**CITY OF TEMPE
DEVELOPMENT REVIEW COMMISSION**

Meeting Date: 05/26/2015
Agenda Item: 3

ACTION: Request for a Development Plan Review for building elevations, site plan and landscape plan, and a Use Permit Standard for an increase in building height from 30 to 33 feet, consisting of 15 single family attached townhomes for THE BLOCK ON ROOSEVELT, located at 233 South Roosevelt Street. The applicant is Scott Garvin of Intent Development Advisors.

SITE PLAN

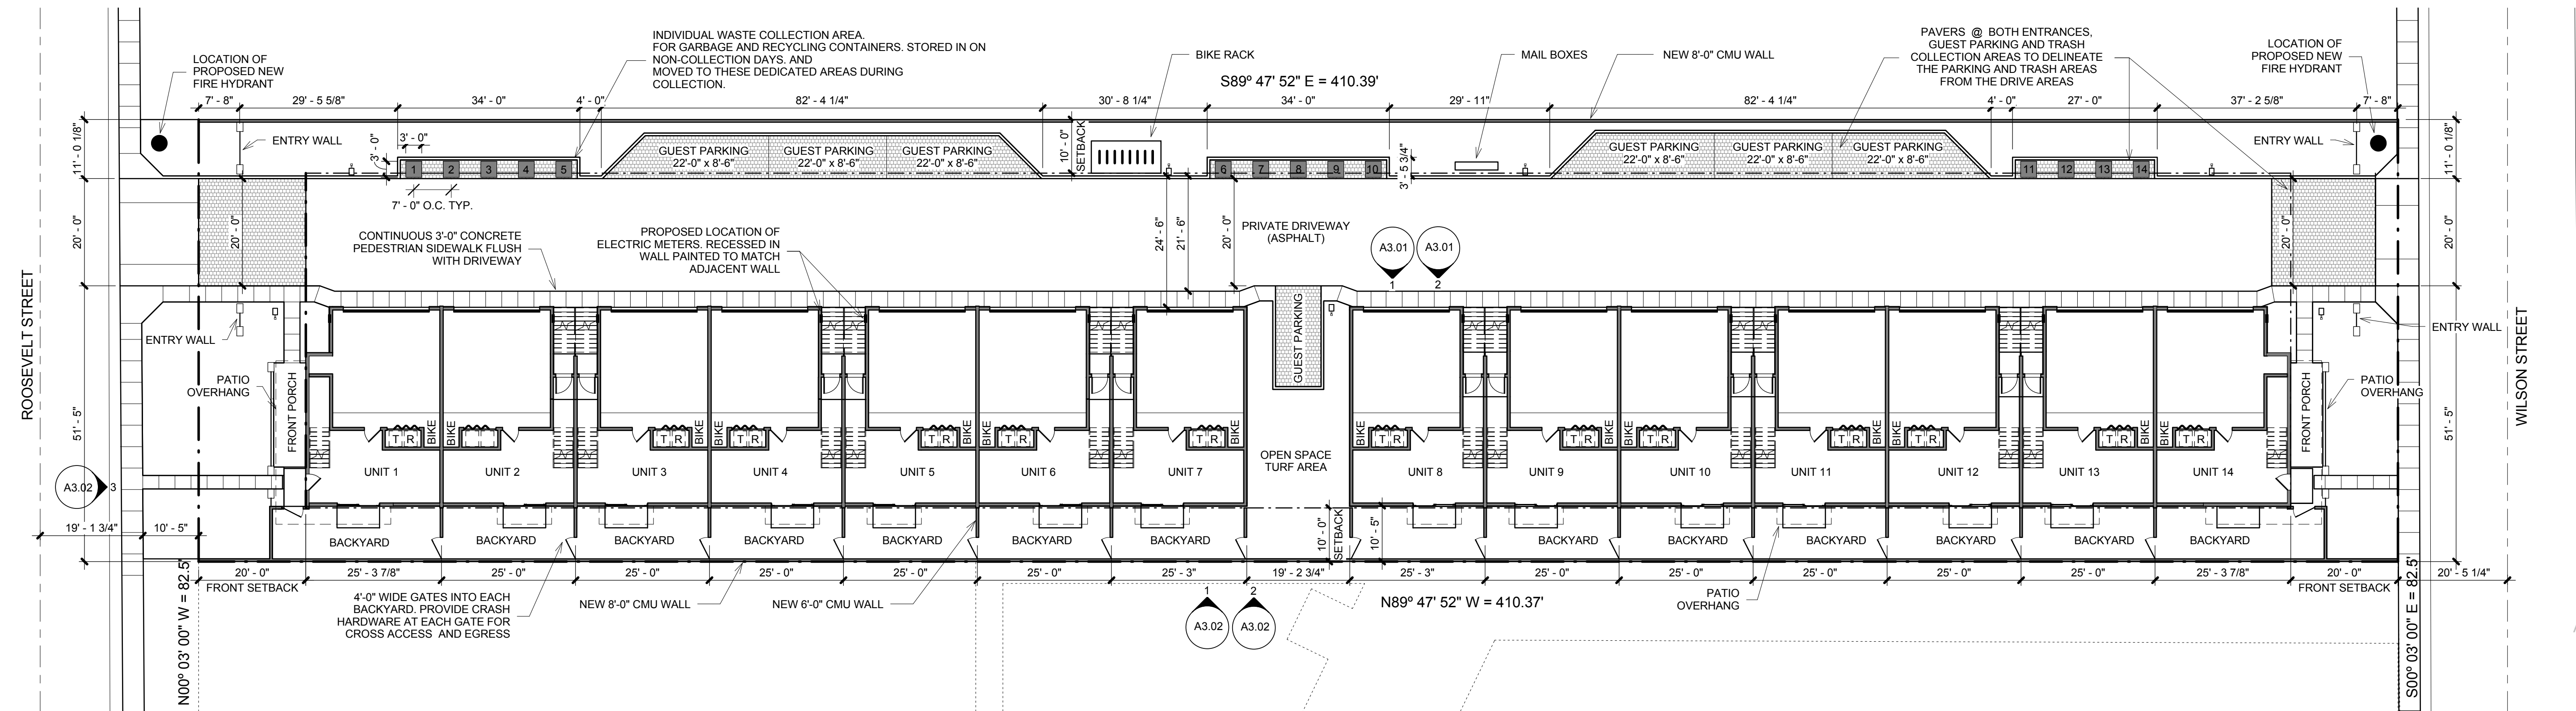
- Provide pavers in the driveway instead of asphalt.
- Work with staff to efficiently arrange and add parking on private drive
- Show the distance from the public sidewalk to the face of the building and provide lush landscape along both street fronts

- Seven guest spaces are available on site, when only three are required by code.
- The distance from the public sidewalk to the face of the building has been dimensioned; the front yard of the project has a 20' setback plus 10' 5" within the right of way to provide lush landscape along both street fronts.

1. Decreased density from 15 units to 14 units and made two buildings. This, decreased the parking strain on the site, added more open space for owner gatherings, and provided room for more guest parking.
2. Increased guest parking from 4 spaces to 7 spaces to ease parking strain concerns.

1. Decreased size of drive opening at Roosevelt and Wilson as well as added a low 24" high entry wall at both entrances to emphasize the fact that this is a private drive and not a public roadway.
2. Created slight movement in sidewalk in front of the units to enliven the hardscape and deter high speed vehicle travel.

LANDSCAPE PLAN

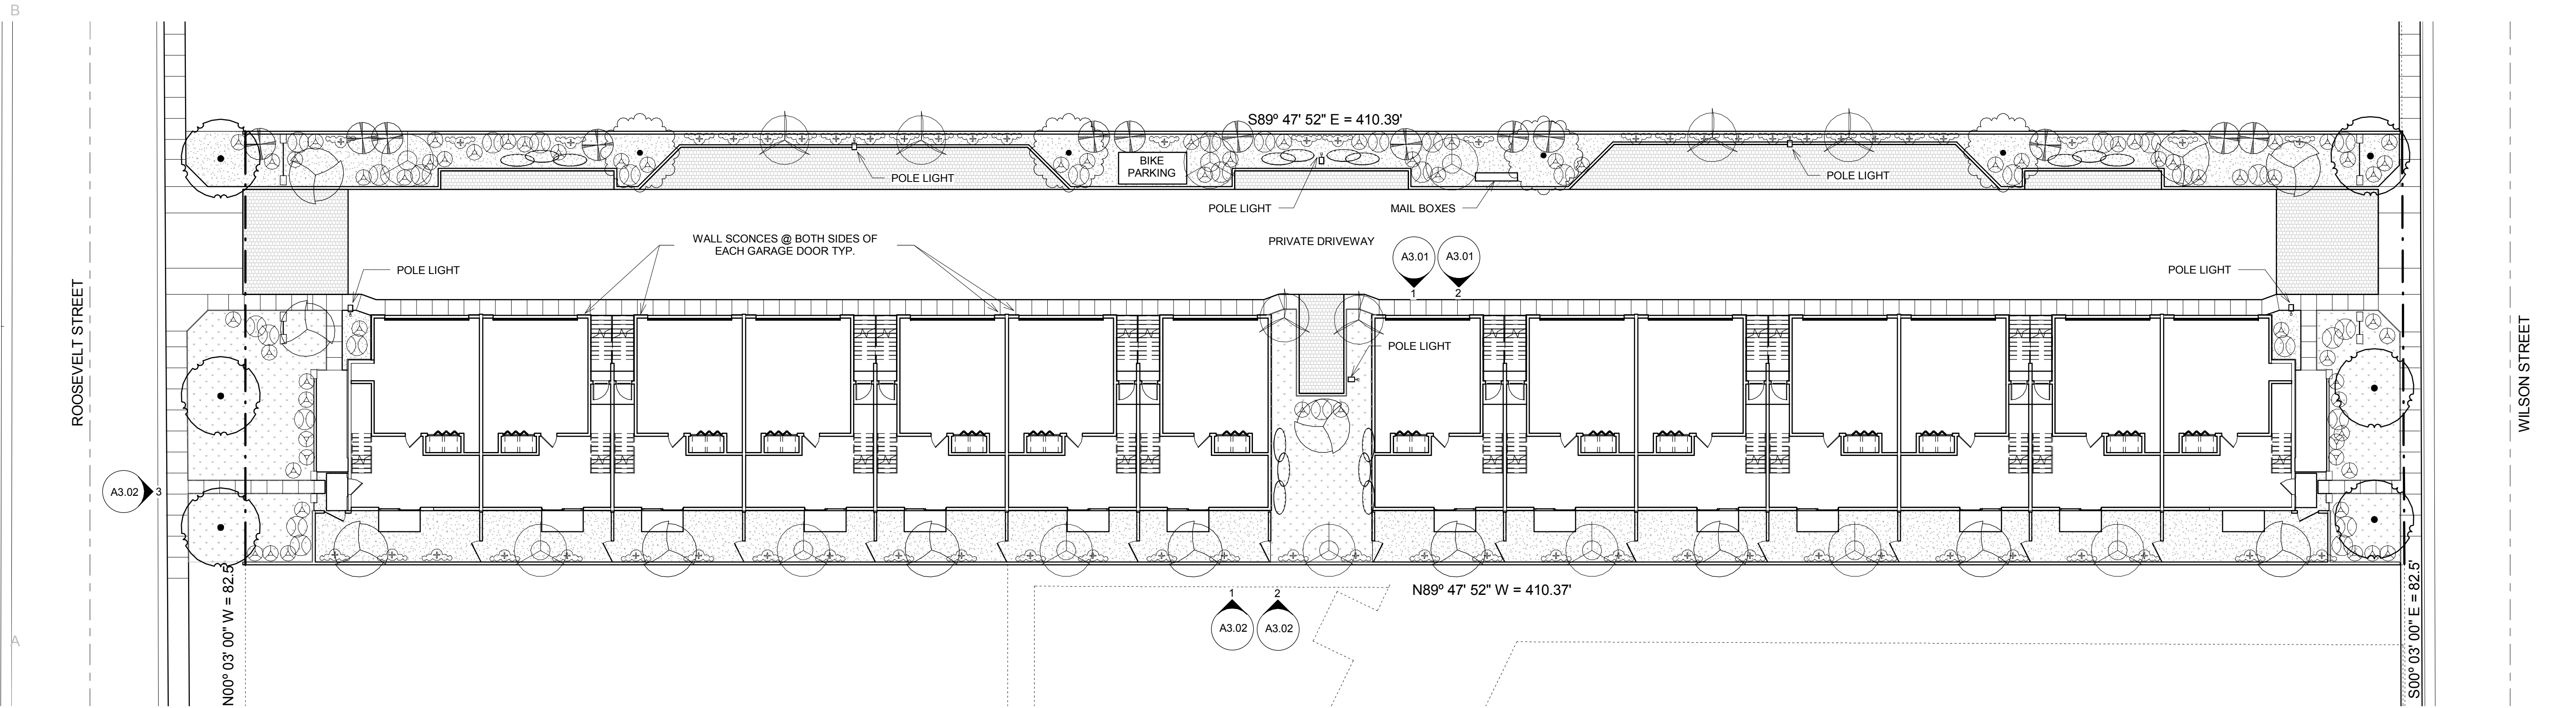
- Provide tall trees on south boundary with an appropriate scale to 3 story building height.
- Condition that the trees in private yards to be maintained and irrigated by the association as part of the common landscape.

- Plant trees on north landscape area at a ratio of 1 tree per 25 linear feet.
- Enhance the materials of the building elevations on the east and west ends of the building to look more residential.

- The applicant is providing Sissoo trees along the street front and an additional 15 trees on south boundary. The proposed tree species are Chaste Tree, which reaches 15' tall at maturity and have purple spring flowers and Chinese Pistache which can grow to 35' tall and wide, and is deciduous for 3-4 months and may provide fall foliage color. This tree may be a bit large for the 10' deep back yards, but most trees tall enough to meet the vertical screening request will have a canopy larger than 10' wide; growth may be controlled by pruning.

- By grouping the parking spaces on the north side, the space available for trees was reduced. Sissoo are located on the street fronts, Pistache are located along the drive entry, followed by Little Leaf Ash and Acacia Willardiana trees. The ratio of 1 tree per 25 linear feet requires 16 trees; separation requirements for trees and light poles, along with the limited planting area makes tree location difficult on the north side, however 16 trees have been incorporated.

2. Increased planting to provide a higher density of coverage as requested.
3. Replaced the Mountain Laurel tree, with Vitex Agnus-Castus and Pistachia Chinensis, as alternating backyard trees, as well as color accents elsewhere on the property.

EAST & WEST ELEVATIONS UNITS 1 AND 14
SCALE: 1/8" = 1'-0"

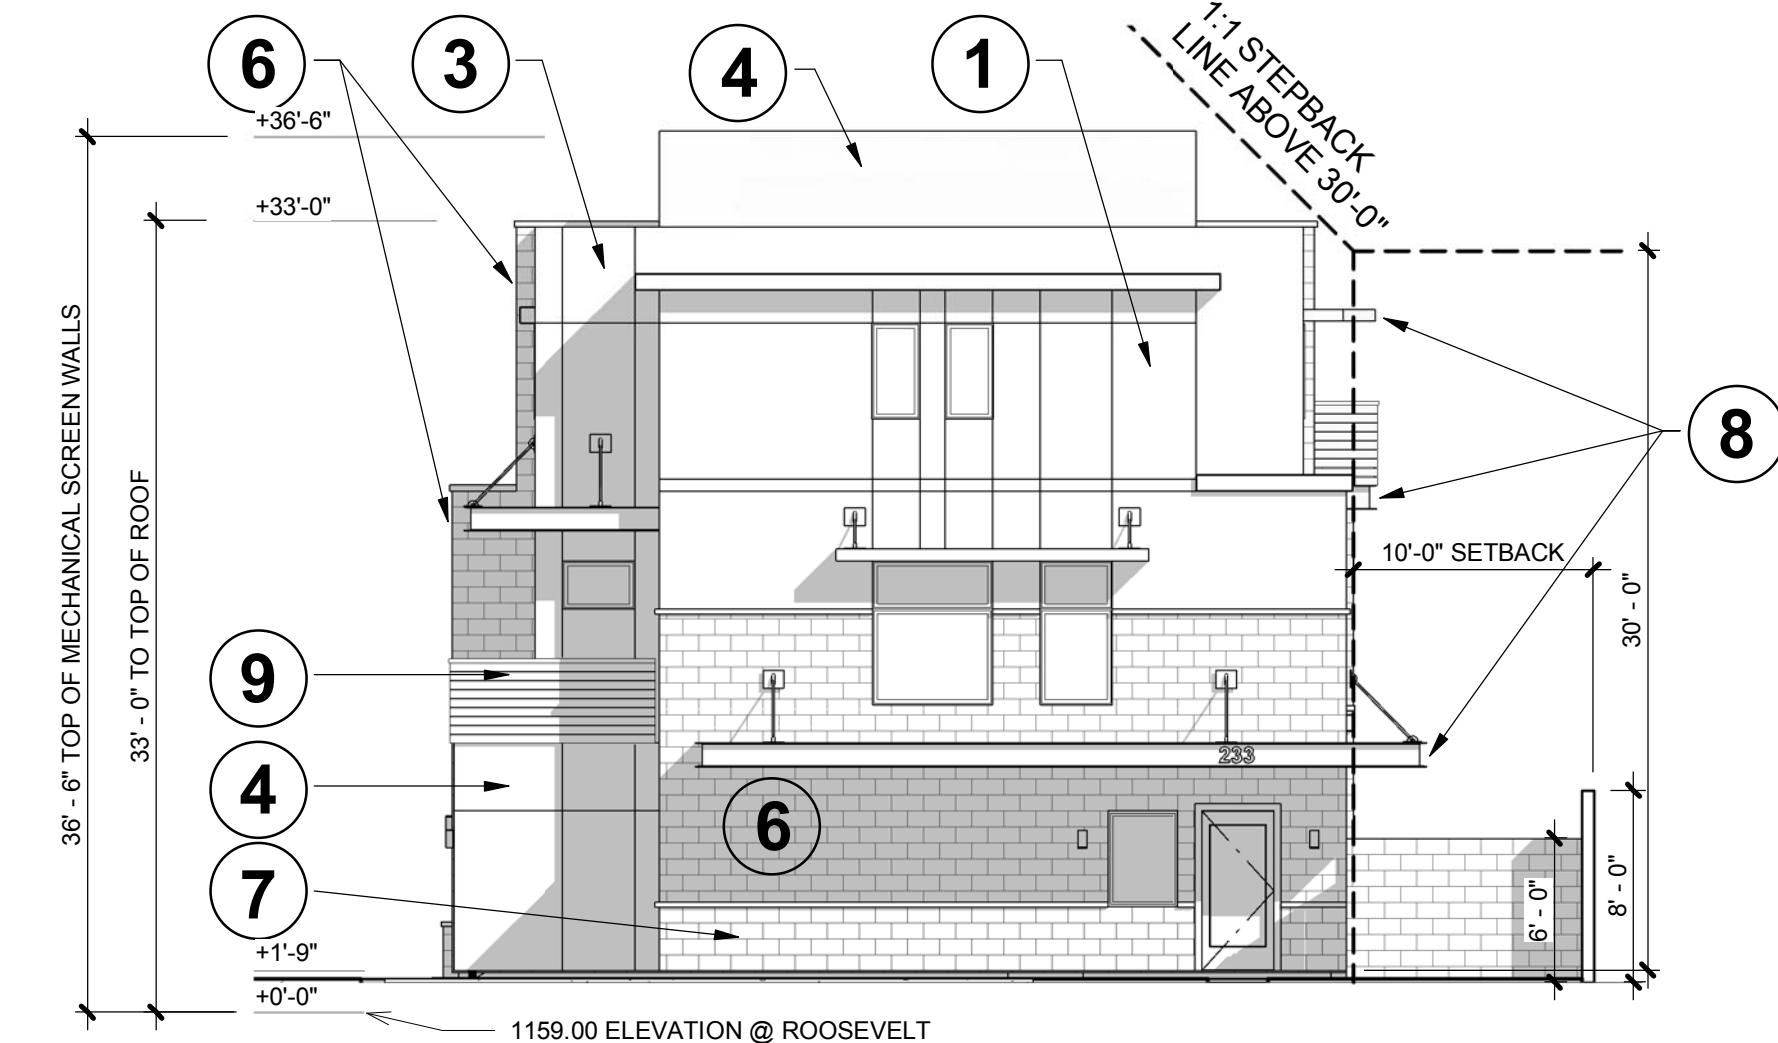
- Reduce the height or set the building back on the west end to step down to the residential scale of the neighborhood.
- Remove one unit and provide more amenity area and possibly more parking

- The building elevations and materials on the east and west ends have been modified to look more residential and address the street. The materials are broken up to include a cmu column and trex board low patio wall to create a front porch on the unit ends, metal canopies over the porch and second floor windows, scoring details in the stucco finish, and a warm taupe cmu wainscot to ground the building with a pedestrian level detail common to older housing styles, while keeping with the contemporary materials, colors and forms. The cmu is a smooth finish, not split faced or honed.

- The west and east end units were modified to reduce the height with a step down to the residential scale of the neighborhood.

5. Building height on the ends of the buildings off Roosevelt and Wilson, Have been lowered to create a more residential feel and add character to the ends of the buildings.
